Planning Commission

TO: Planning Commissioners
FROM: Katie Peterson, AICP, Senior Planner
RE: Review of Revised Plans to COFA-03-23-017836
DATE: 10/25/2023
CC: Kevin Icard, AICP, Director of Growth Management

RE: Big Blue Marble Cypress Ridge – Planning Commission Comment Responses

Sheet No.
A 201

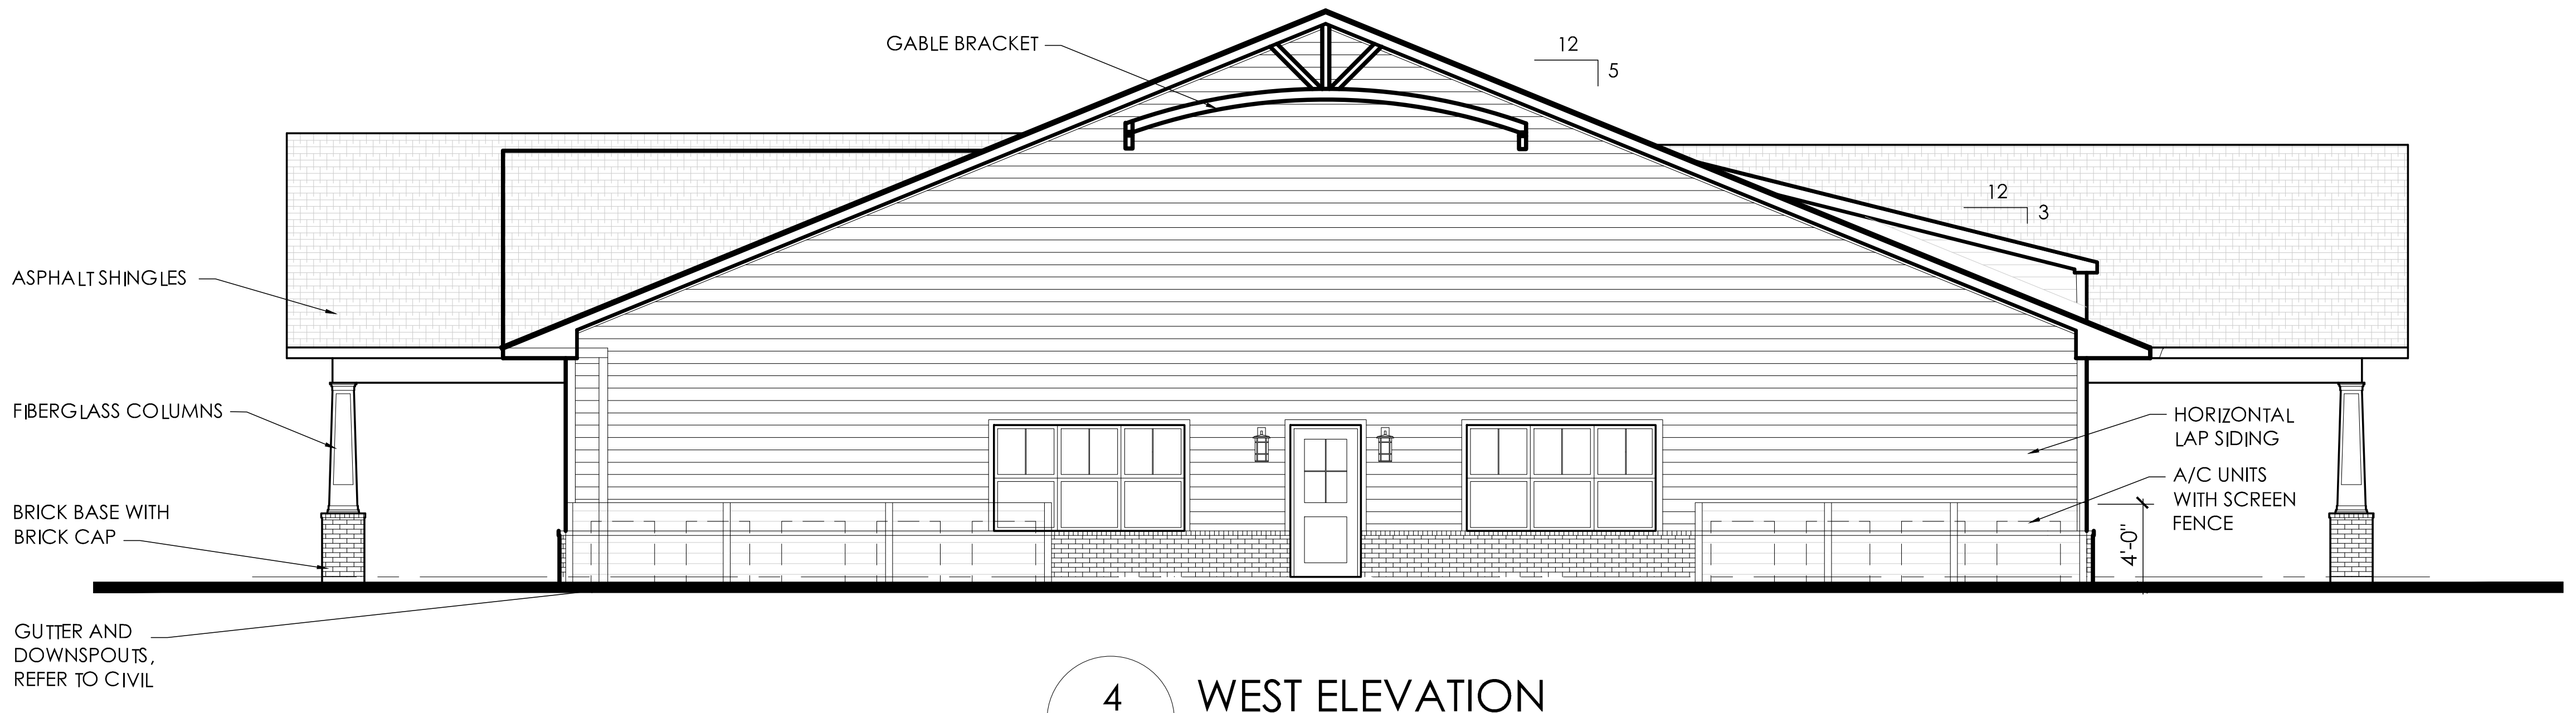
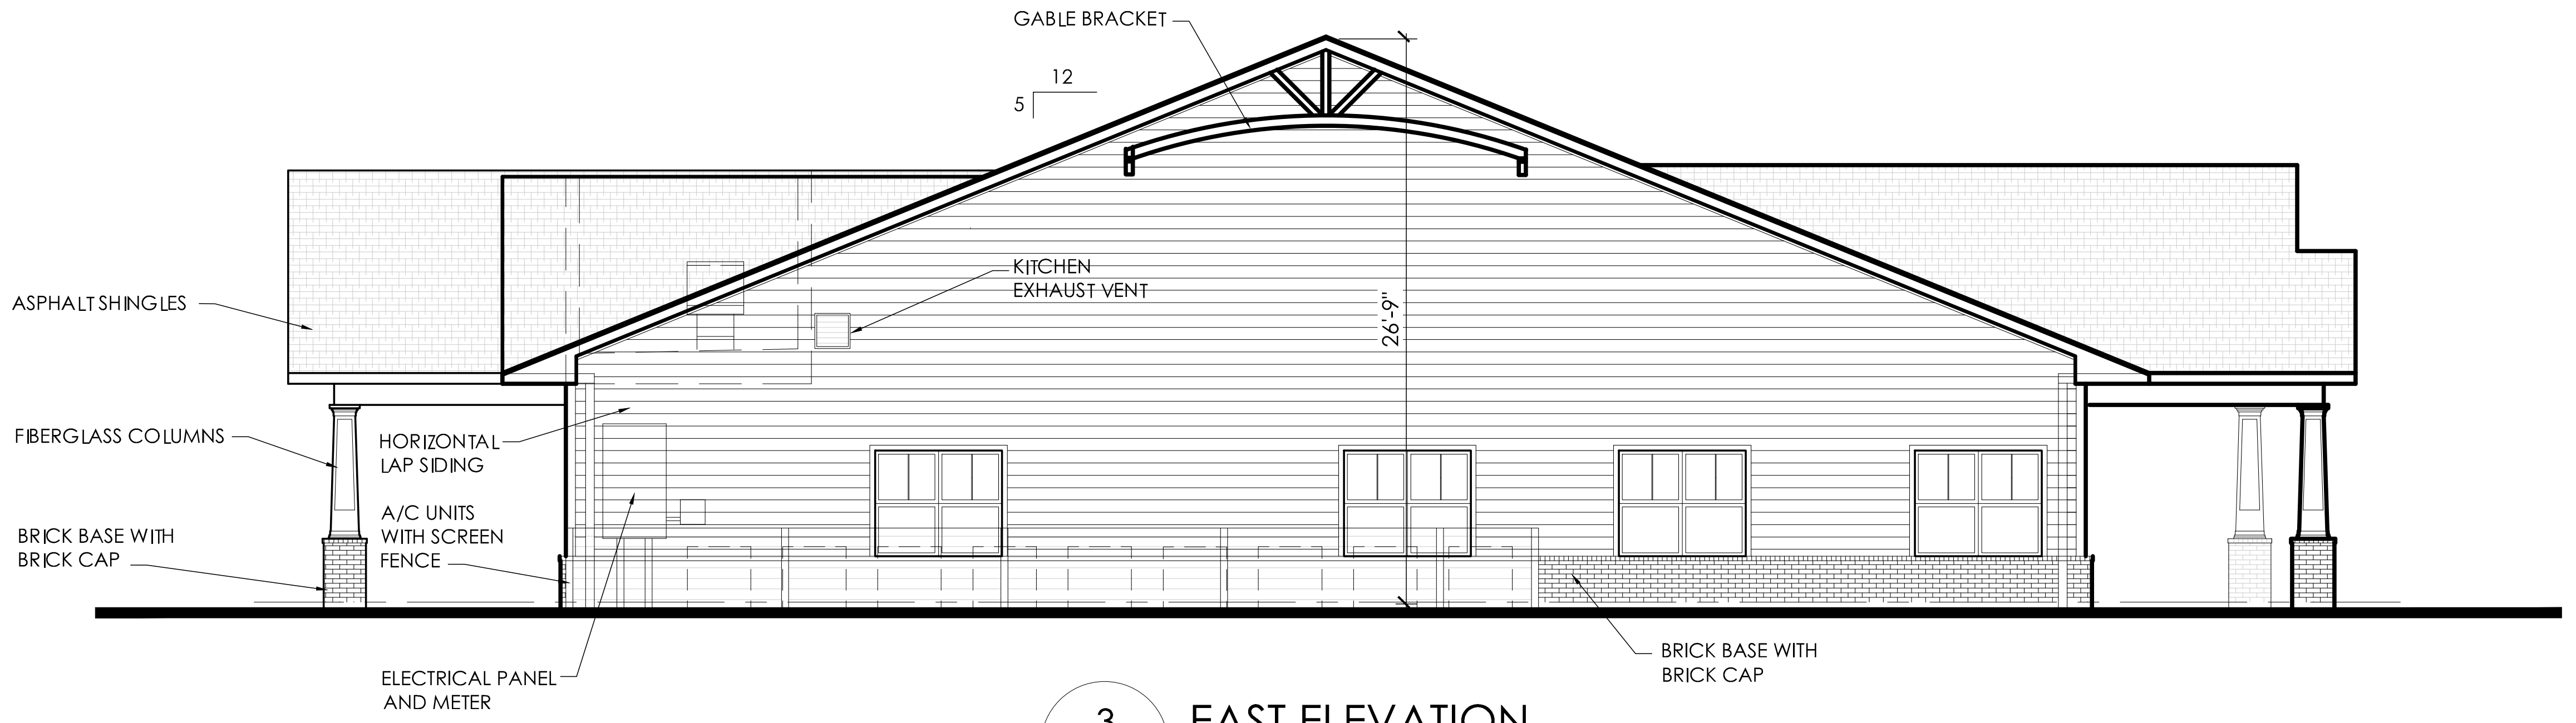
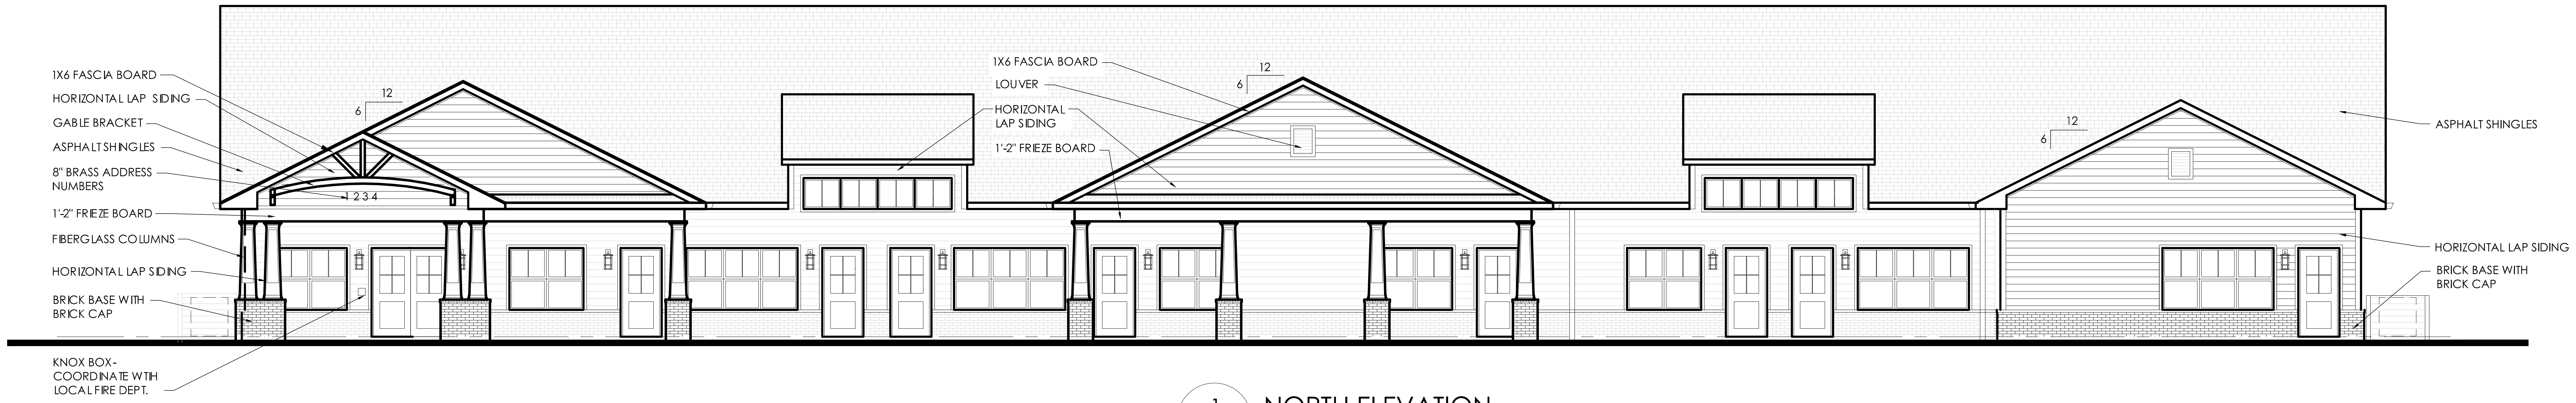
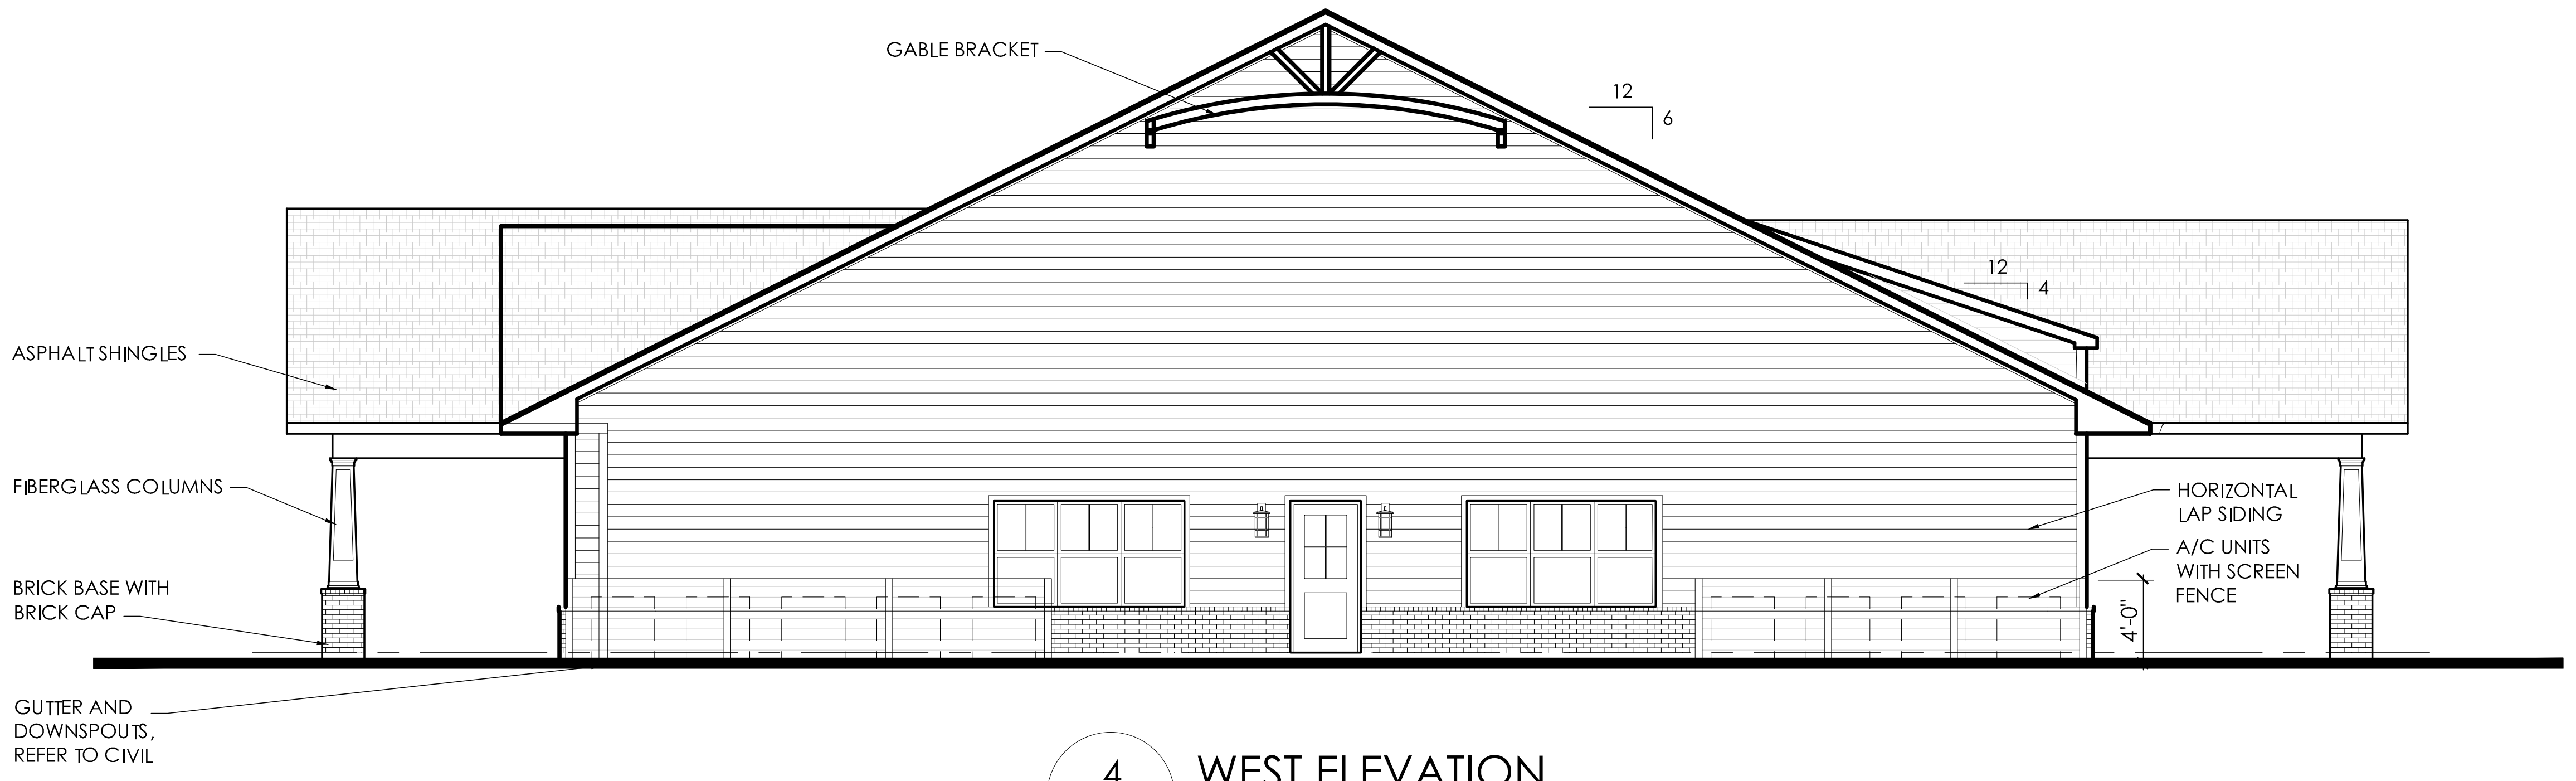
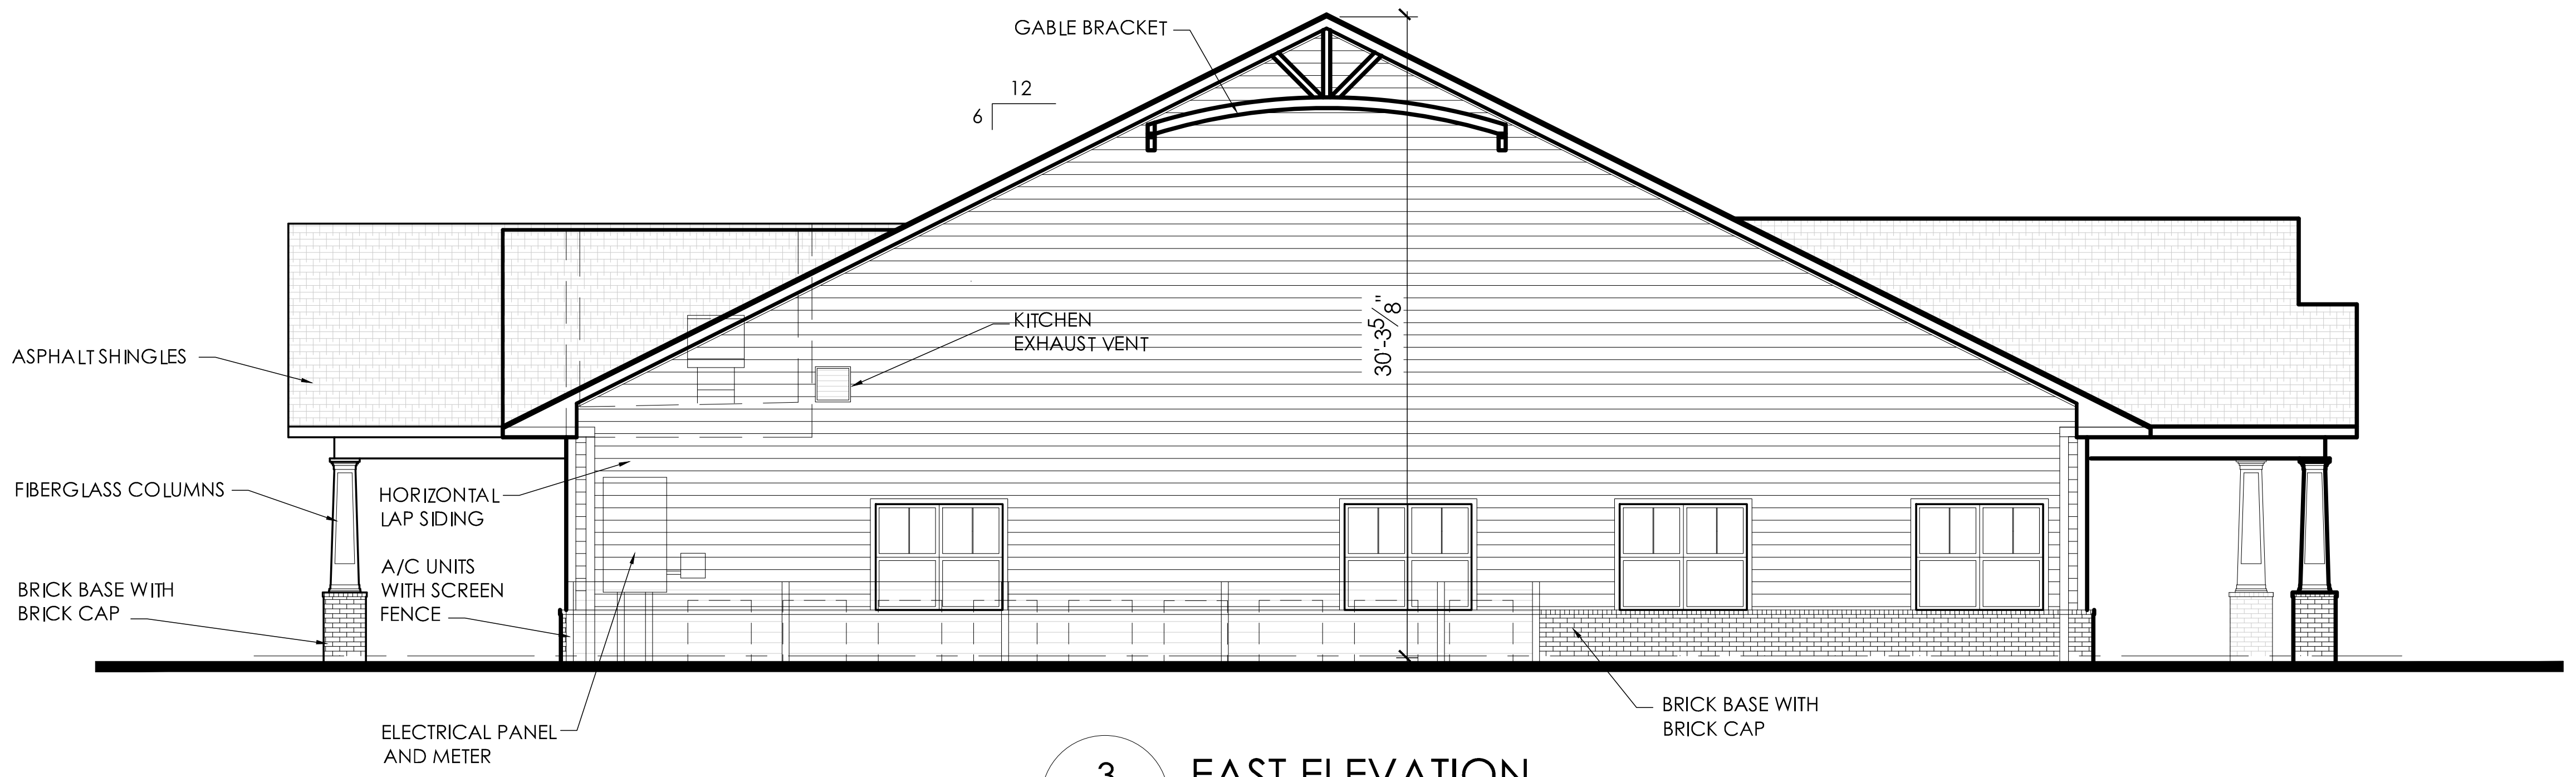
7. The shed roofs on the dormers were proposed at 3:12, which are required to be no less than 4:12. Options 2 and 3 address the roof pitches. Option one does not meet this requirement.
8. The columns, rather than the capitals, need to be aligned with the beam.
9. The intake on the front elevation must be below the roofline, including curbing and mechanicals, or moved to the side or rear elevation as it will not be approved should be visible from the front elevation once installed.
10. Consider increasing the height of the mechanical yards to ensure HVAC is concealed and electric meters are more concealed.
11. Move the three ridge vents on the roof to the rear elevation as they are not permitted on the front (HWY 170) elevation.

c. The shed roofs on the dormers should be increased to pitch 4:12.
      - Two (2) versions of the updated elevations have been provided with our resubmittal to allow the Planning Commissioners to select their preferred elevation.
      - One version depicts the 12:6 roof and 12:4 pitch of the dormers.
      - One version depicts the 12:5 roof and 12:3 pitch of the dormers.
